SHEET NO.
EX-1

CONCEPT SITE PLAN

OPPIDAN COFFEE
BLOOMINGTON, MN

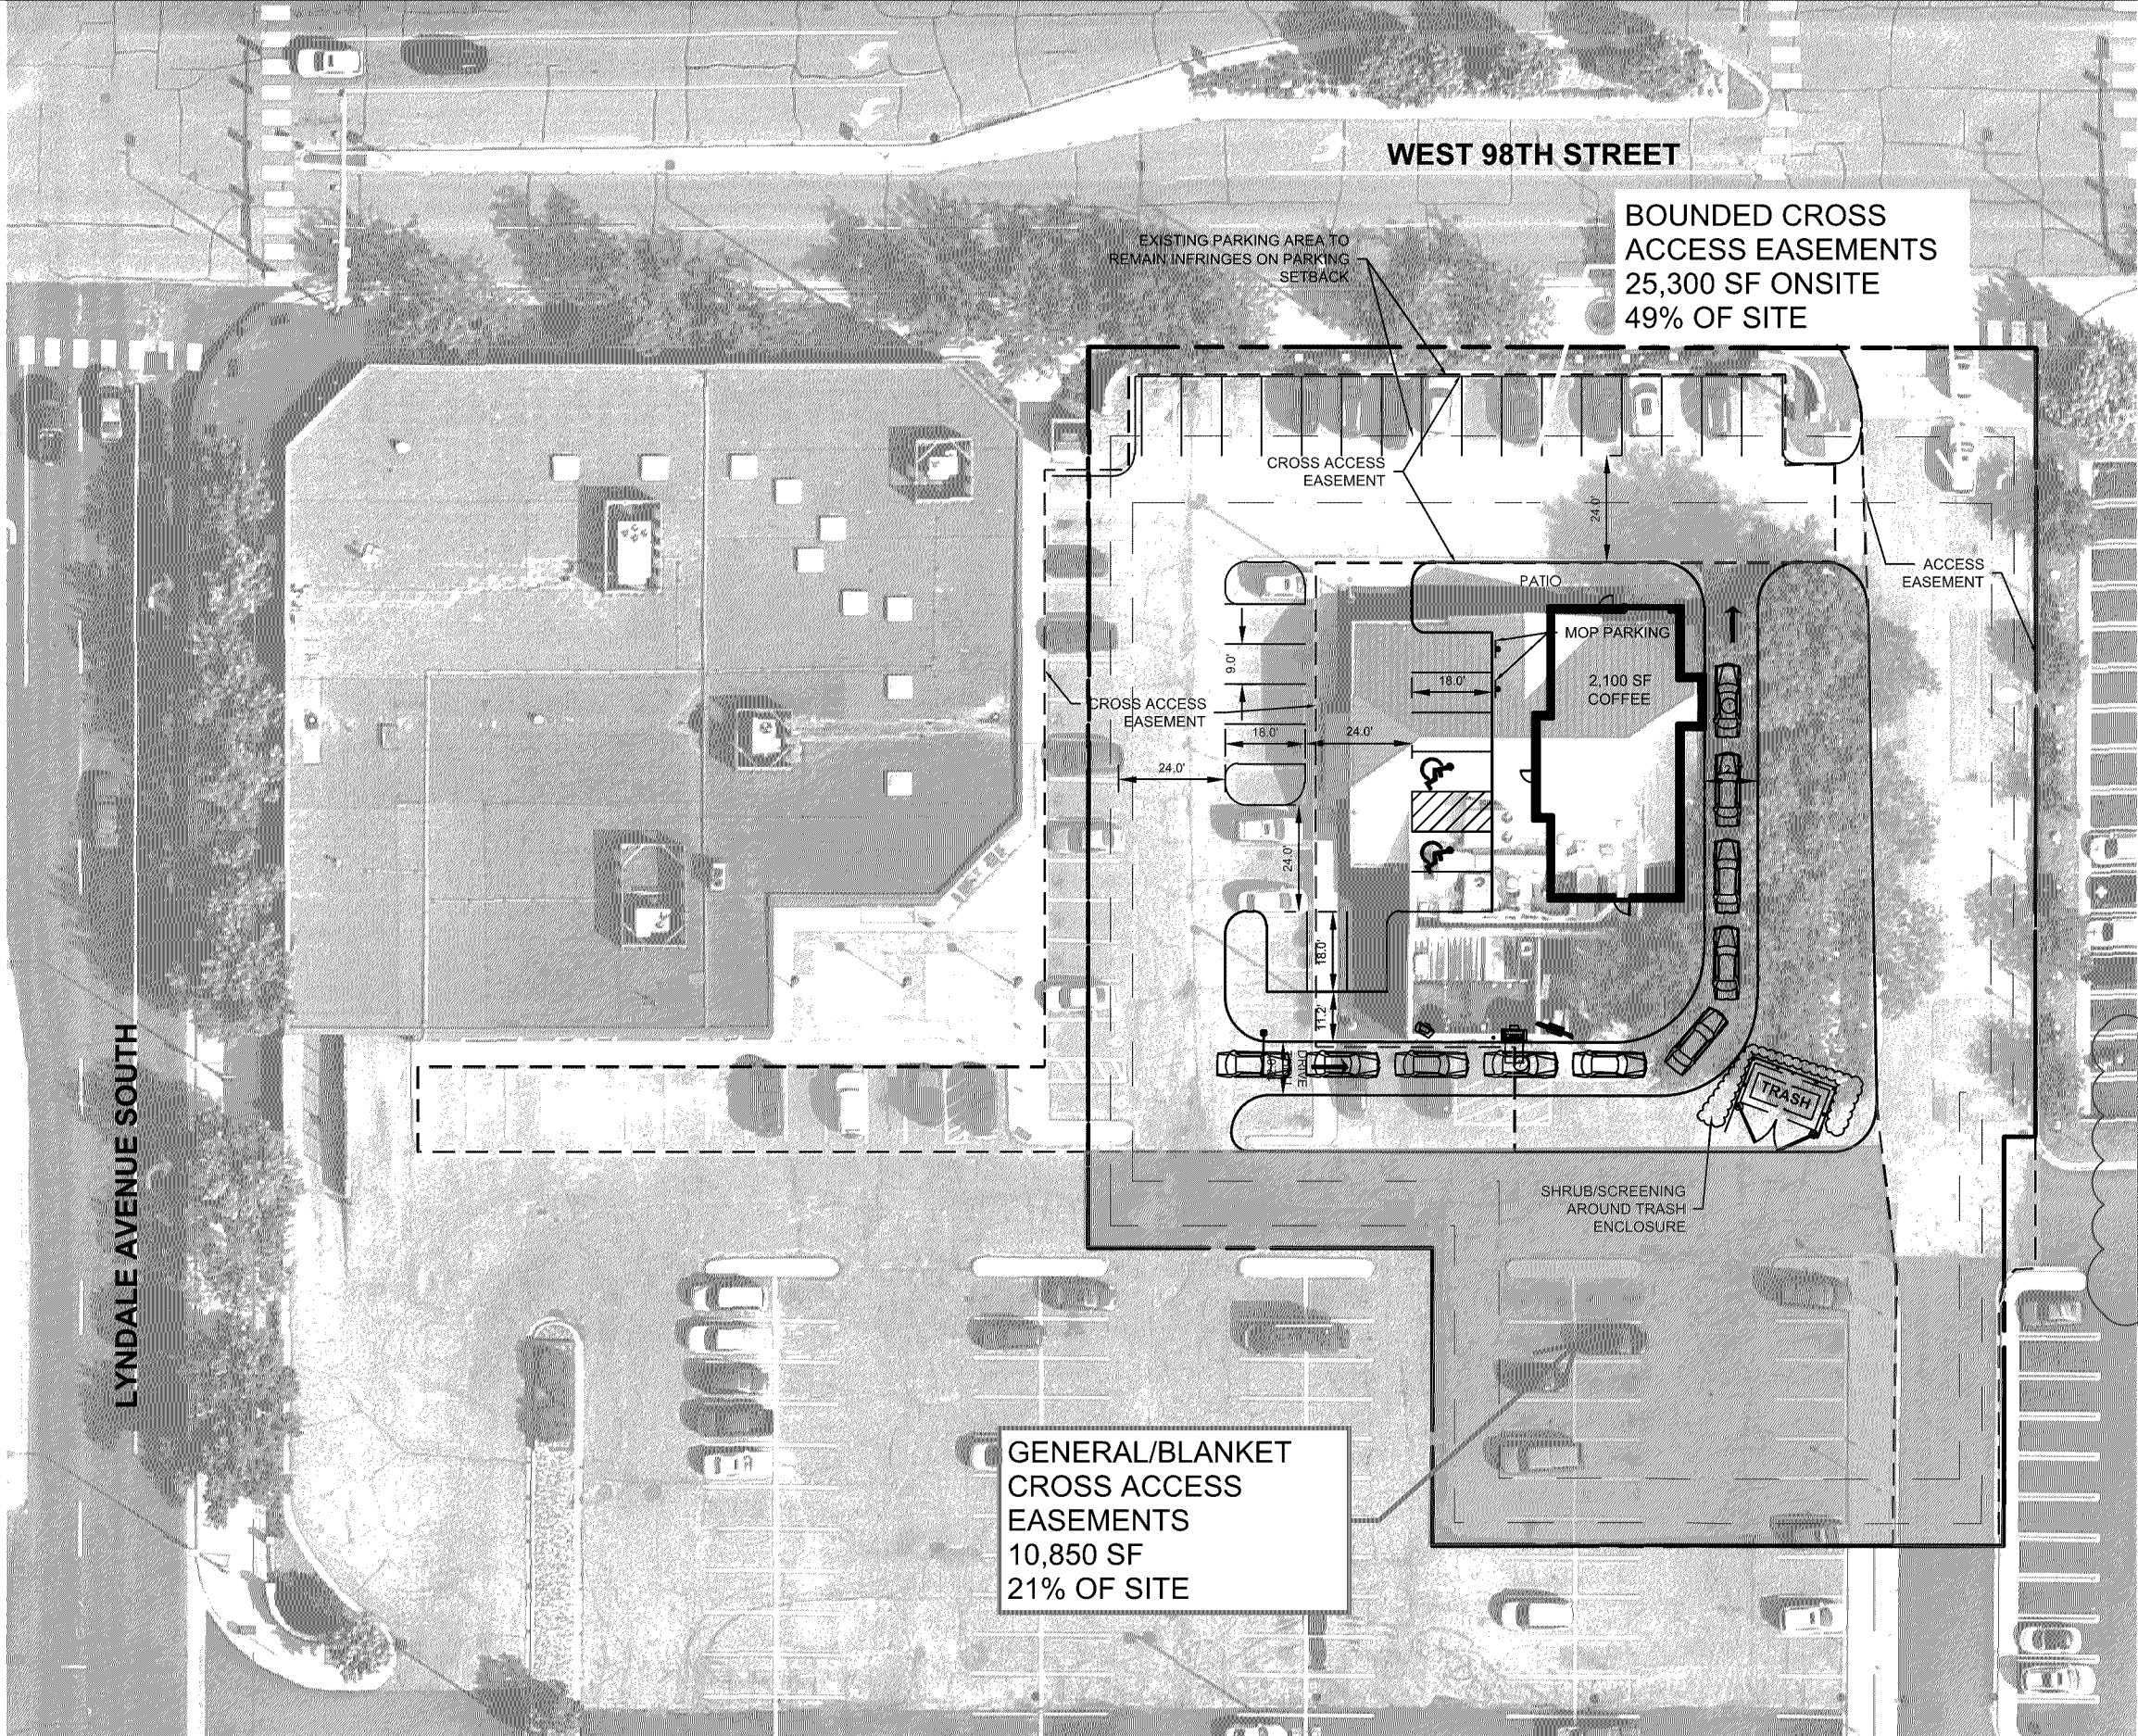
Trash and recycling storage must comply with Section 21.301.17 of the City Code. External trash storage is not permitted. The finish plan of the internal trash room must meet the performance standards for food service facilities.

Show sidewalk realignment and connection in this modified area.

North access is too close to traffic signal and driveway traffic queue. Right-in only at this north driveway is recommended as it would function more safely and without backing up the drive through. Traffic exiting the site would go around to southern drive aisle.

Show the sidewalk through the site which should remain and/or be enhanced

Drive-through must have six stacking spaces from the first point of contact, which is the order board in this case. Stacking spaces must be a minimum of ten feet by 20 feet in size. See Section 21.301.05 of the City Code for drive-through standards.

Label modified drive/access aisle width

Minimum 7' sidewalk width adjacent to parking stalls

Building is required to be sprinklered per MSBC 1306.

Emergency responder radio coverage meeting the requirements of appendix L in the 2015 MSFC shall be provided throughout the property and within the structures.

Appliances/cooking producing grease laden vapors requires a hood and suppression system.

Hydrant coverage shall be provided within 50' of the FDC and within 150' of all portions of the structure.

Provide for the new structure and maintain for existing structures emergency vehicle access throughout the property.

Must meet current MN State Building Code

Must meet MN Accessibility Code

SAC review by MET council will be required.
